ENVIRONMENTAL RISK ASSESSMENT

The Breakers Yard, Barracks Road, Assington, Sudbury, Suffolk, CO10 5LP

Version:	1.2	Date:	22 June 2023		
Doc. Ref:	BAR-3041-D	Author(s):	CP	Checked:	AAL
Client No:	3041	Job No:	001

In relation to planning application DC/21/02579, Suffolk County Council as Lead Local Flood Authority (LLFA) have requested additional information regarding the drainage strategy for the proposed development. The points raised by the LLFA have been included below for reference, with our responses following each relevant point:

CLIENT APPROVAL	
A - APPROVED	
B - APPROVED WITH COMMENTS	
C - DO NOT USE	
STATUS	PURPOSE OF ISSUE
S1	PRELIMINARY
TITLE	Exceedance Flow Plan

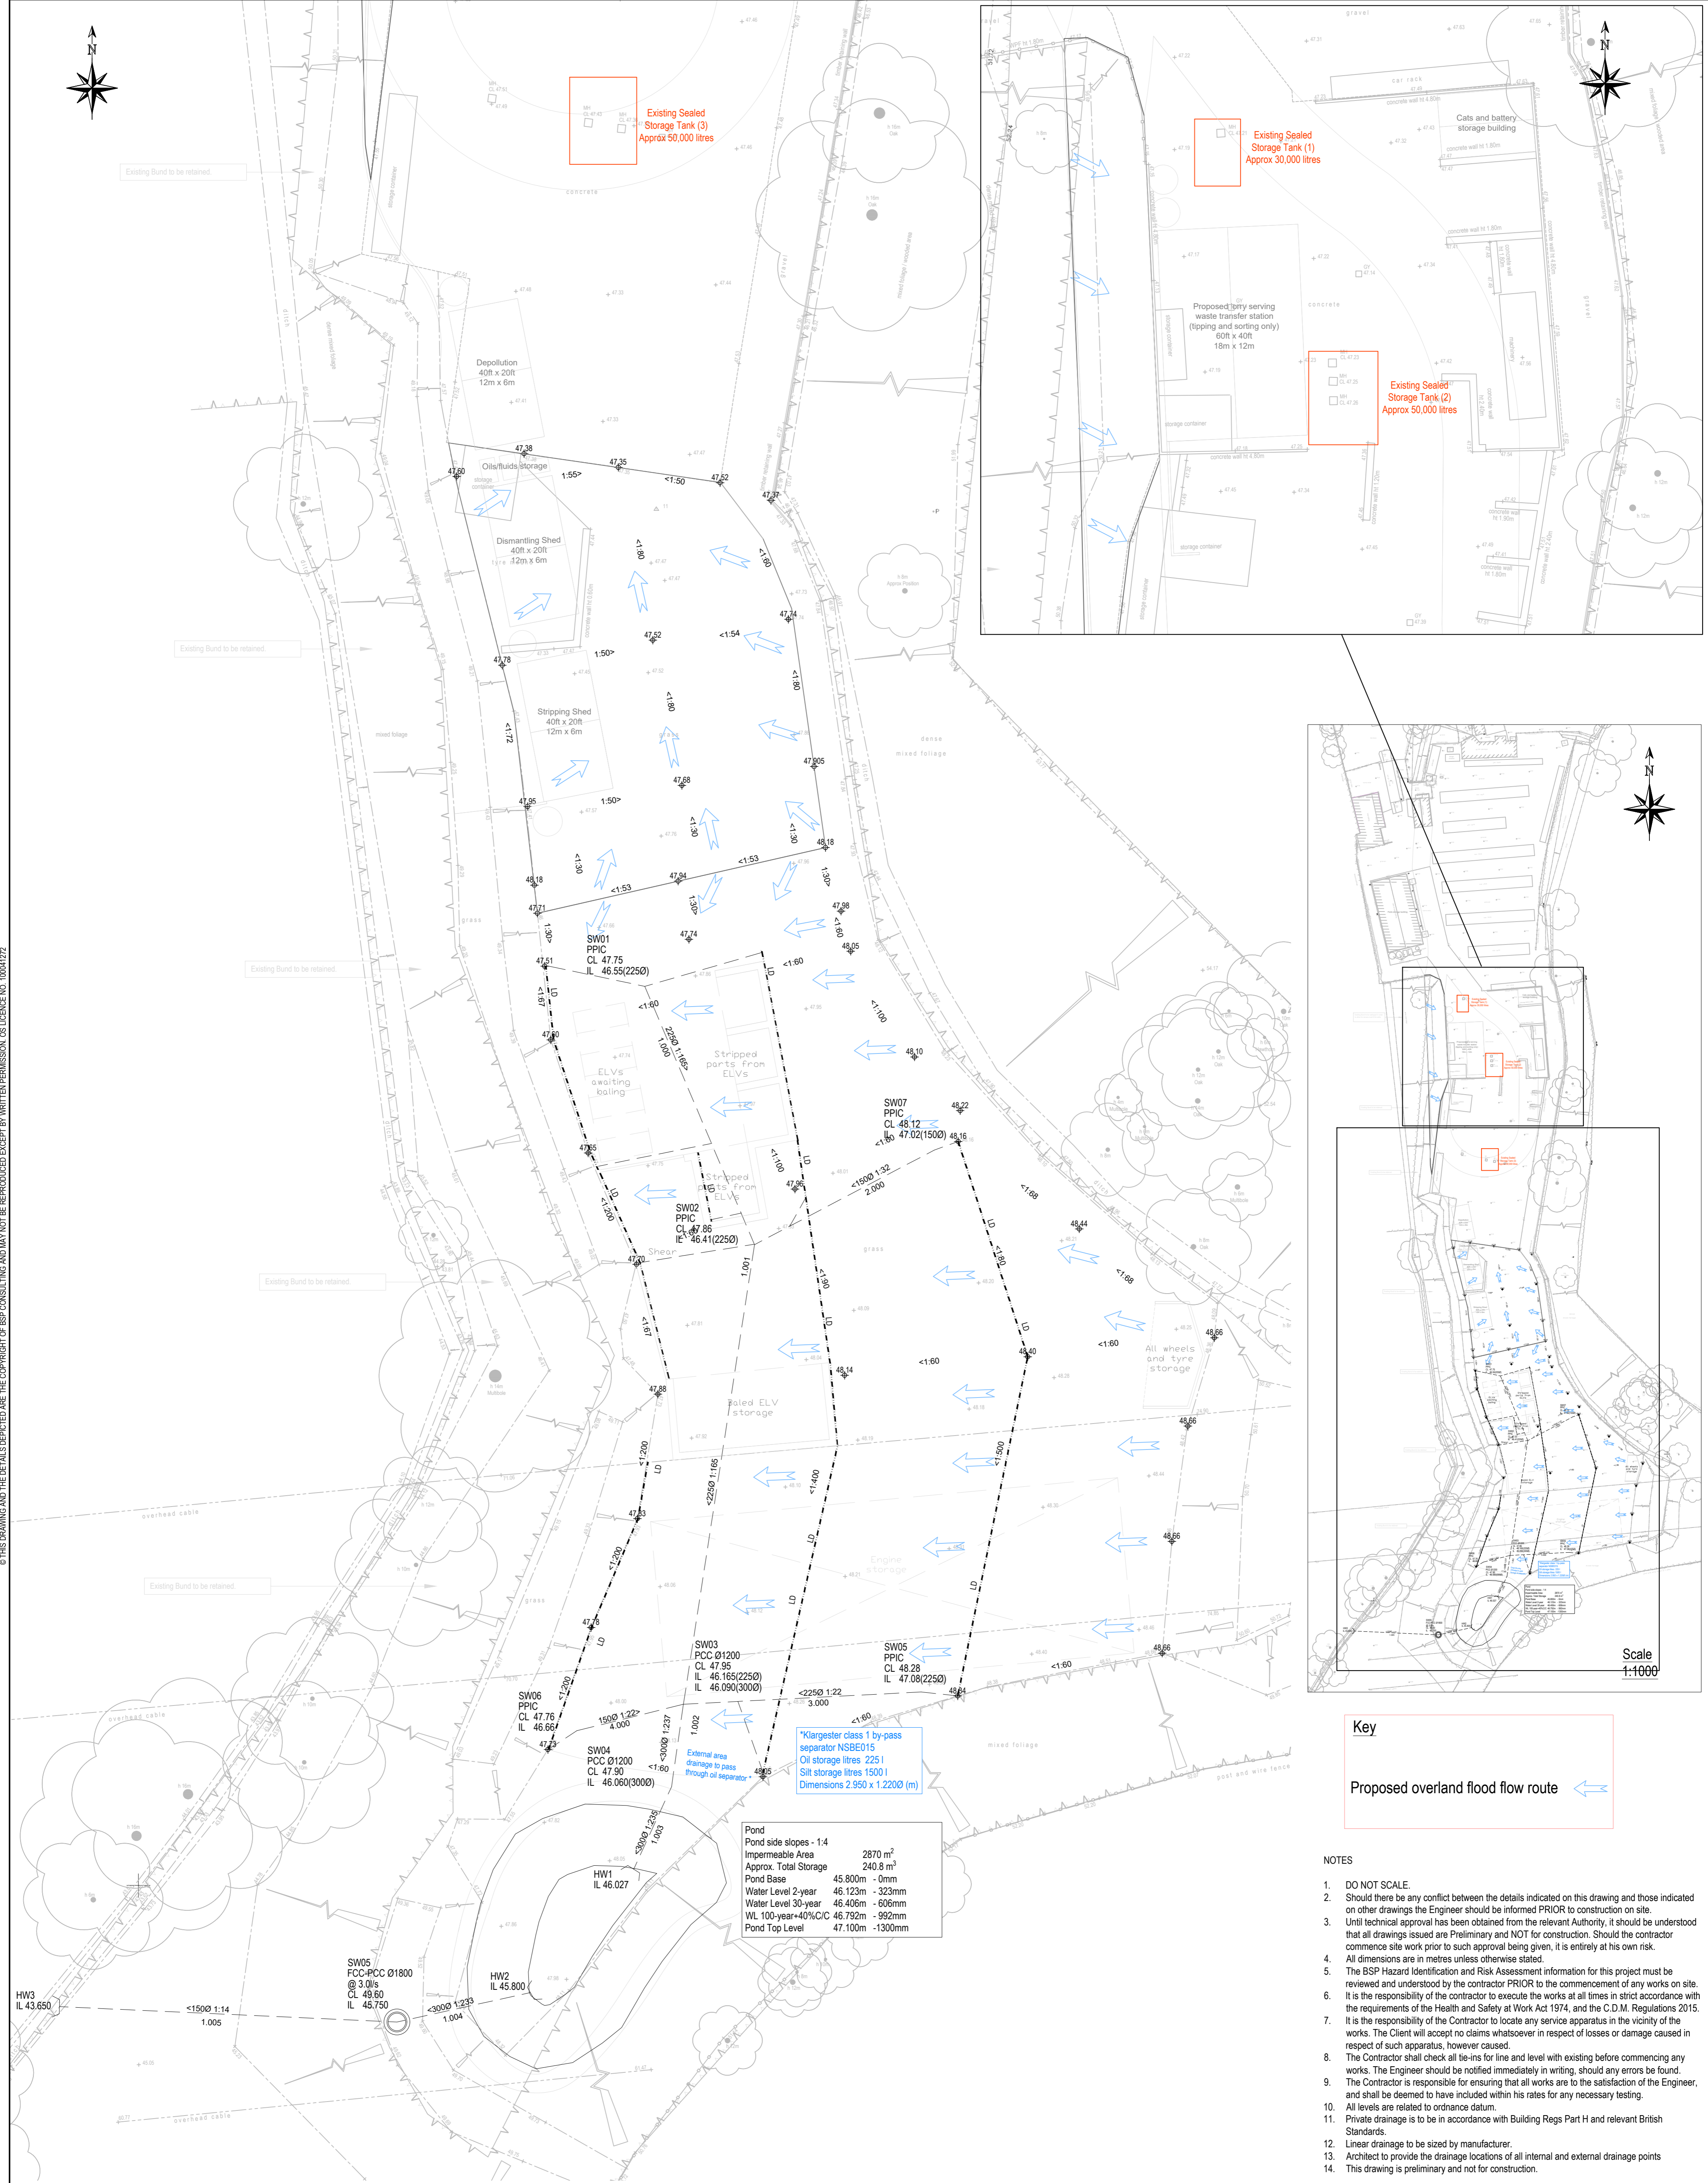
6. **Update the flood flow exceedance plan to show the exceedance routing if the basin outlet gets blocked or the basins design capacity is exceeded.**

We have updated the drainage strategy plan to include exceedance flow routing in the event of a failure, as requested.

CLIENT APPROVAL	A - APPROVED
	B - APPROVED WITH COMMENTS
	C - DO NOT USE
STATUS	PURPOSE OF ISSUE
S1	PRELIMINARY
TITLE	Drainage Strategy

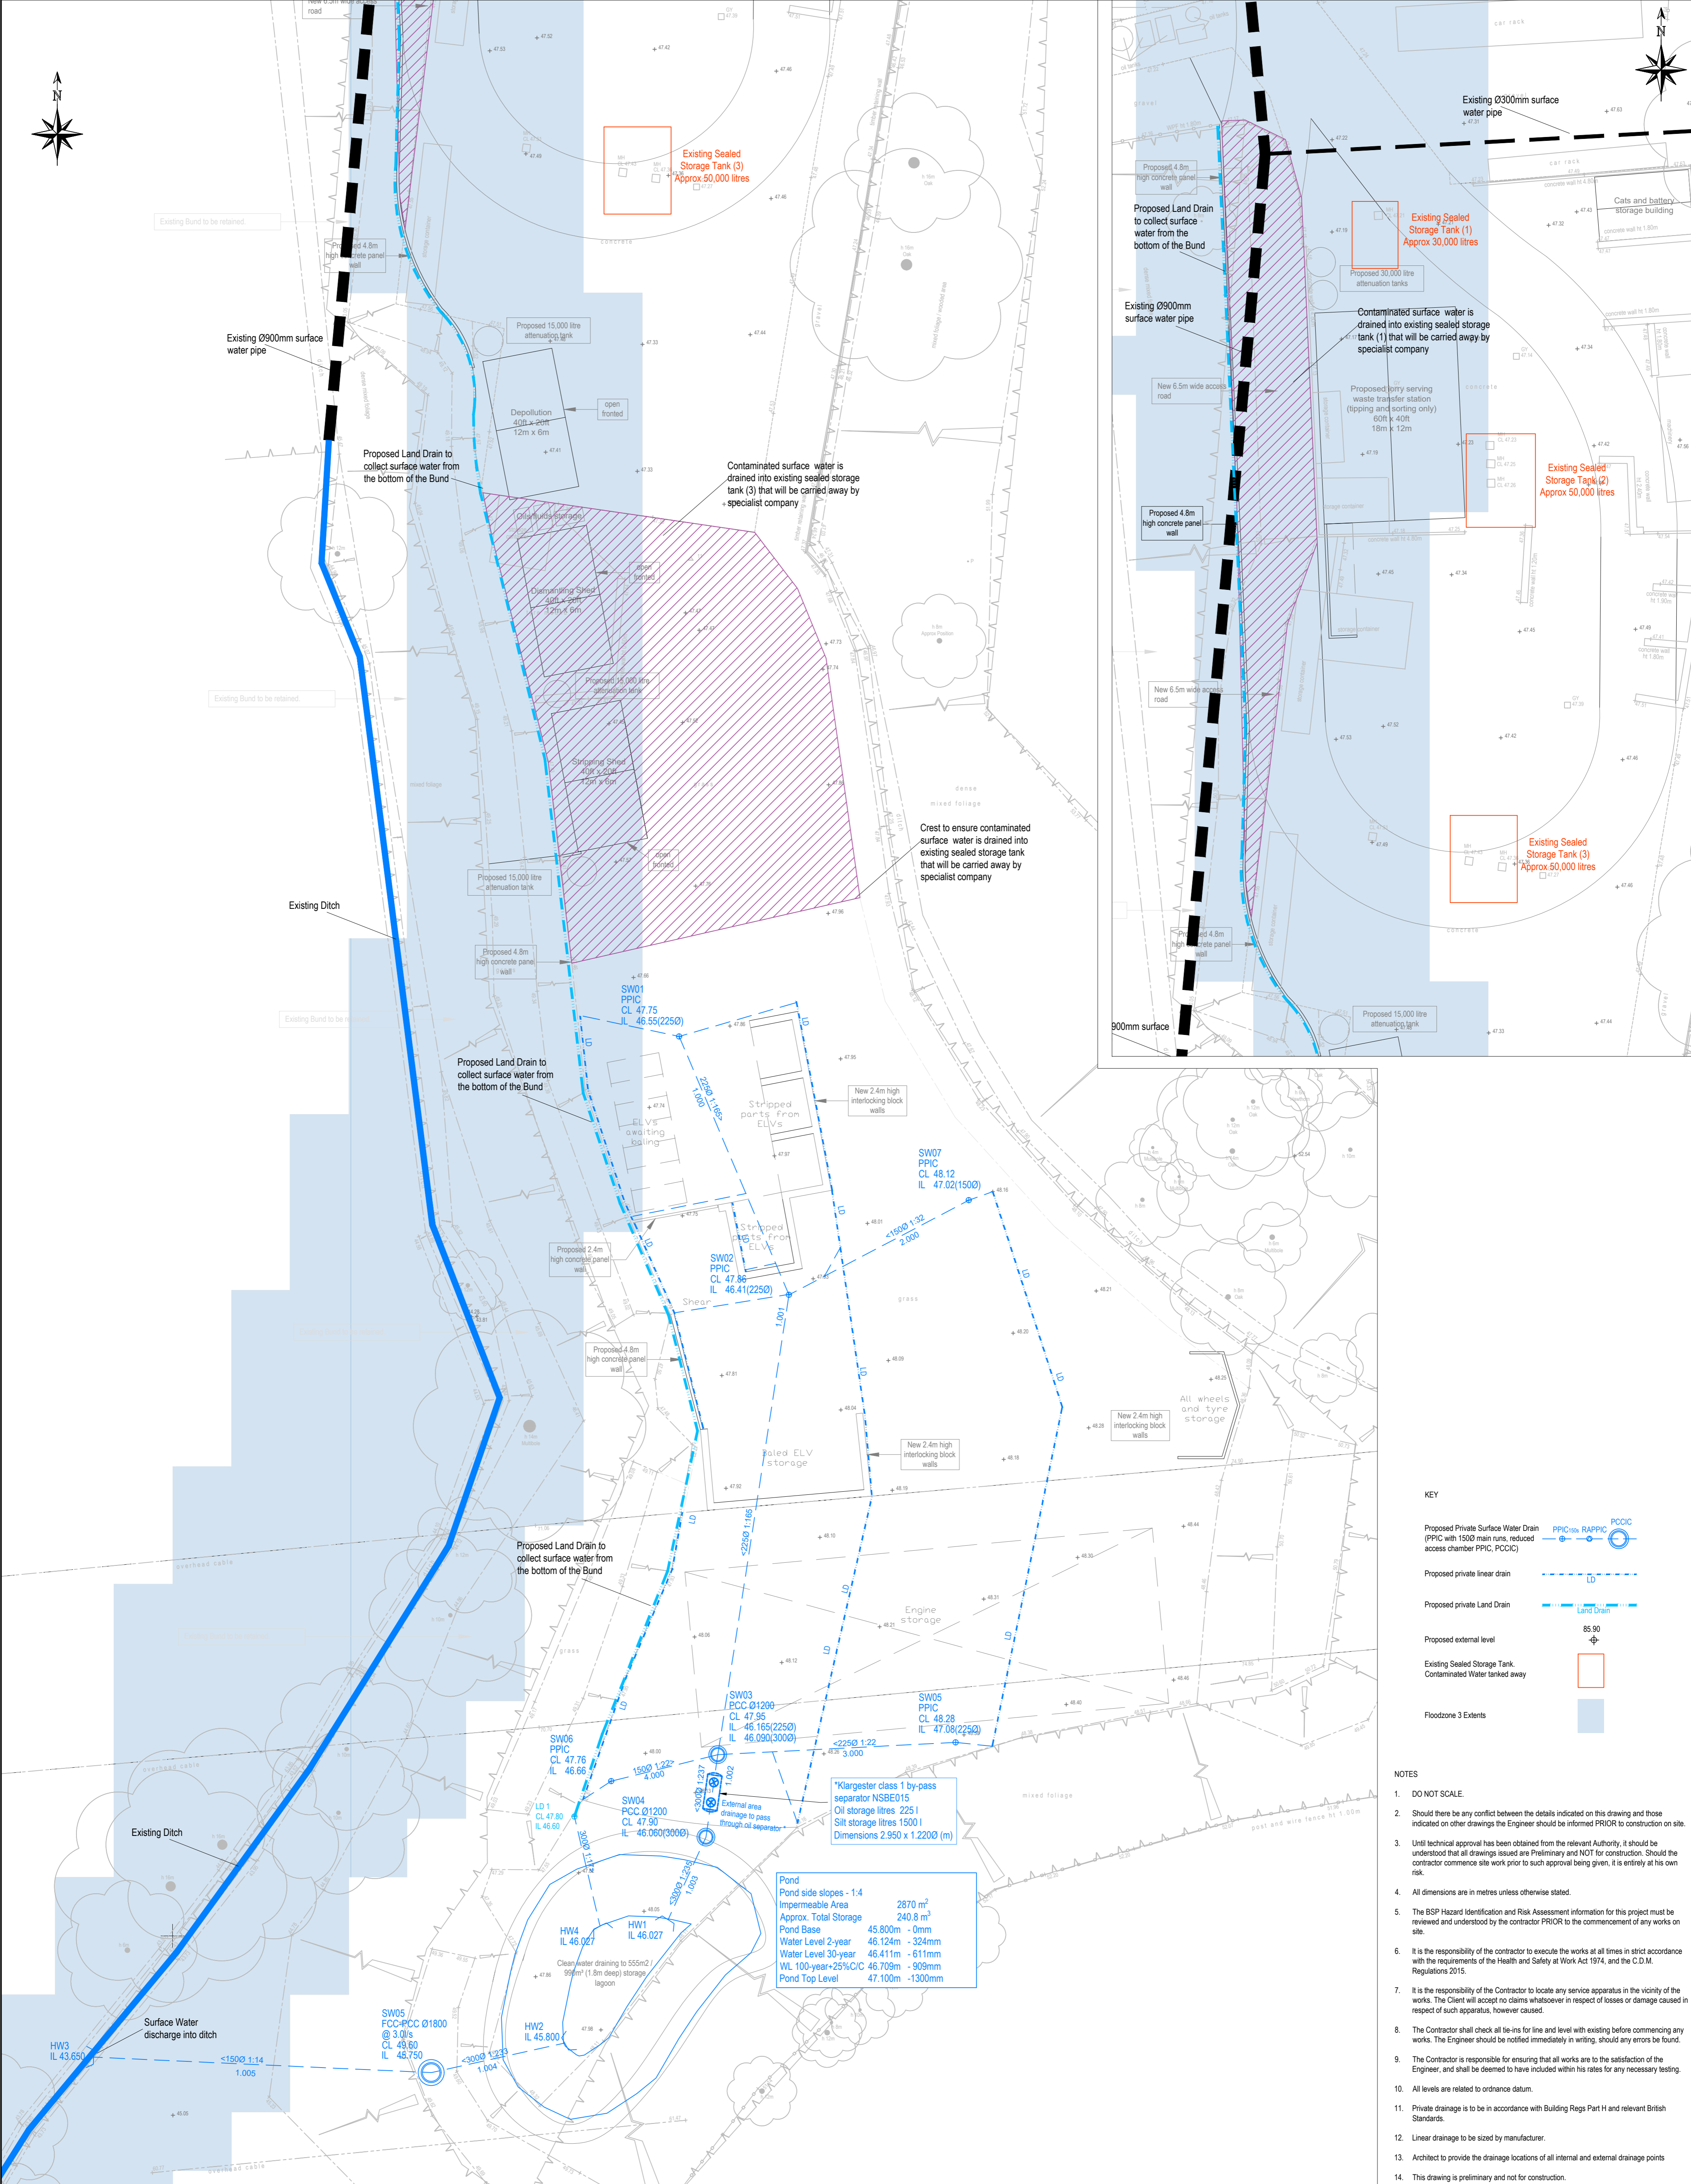
The drainage strategy plan has been updated, clearly demonstrating that the proposed basin is outside of Flood Zone 3.

Change to the HydroBrake type	FE	04/05/23	PN	04/05/23	TG	04/05/23	
First Issue	FE	30/01/23	PN	30/01/23	TG	30/01/23	
SCALE @ A1	1:250		ISSUING OFFICE	NOTTINGHAM		PROJECT NUMBER	22-0611
